**Proposal #22: 4656-07-71, WOSC 2023158**  
**T. Buchanan, County Line Road**  
**Branch of Plum Creek Bridge**  
**Local Street**  
**Outagamie County**

## Letting of January 10, 2023

This is Addendum No. 01, which provides for the following:

STATE PROJECT NUMBER  
4656-07-71

CROSS SECTION, QUANTITIES, & NOTES  
SHEET 2 OF 9  
37

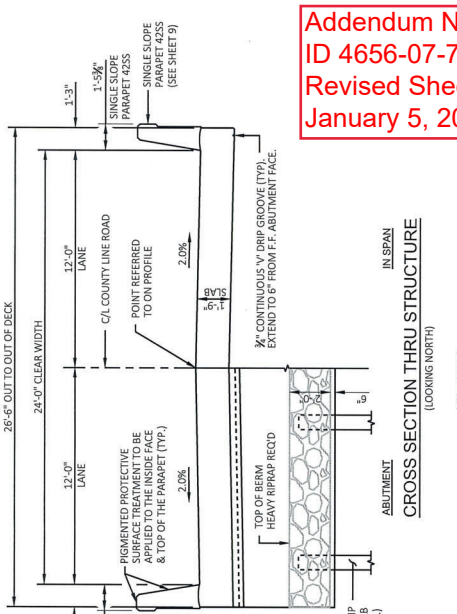
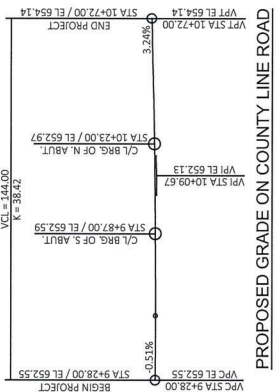
Revised Plan Sheets – ID 4656-07-71	
Plan Sheet	Plan Sheet Title (brief description of changes to sheet)
37	Added Bid Item 614.0150 to Structure Quantities

614.0150	ANCHOR ASSEMBLIES FOR STEEL PLATE BEAM GUARD	EACH	4	4	-	8
645.0111	GEOTEXTILE TYPE DF SCHEDULE A	SY	27	27	-	54
645.0120	GEOTEXTILE TYPE HR	SY	170	140	-	310
	NON-BID ITEMS	SIZE	-	-	-	4' x 4'
	FILLER
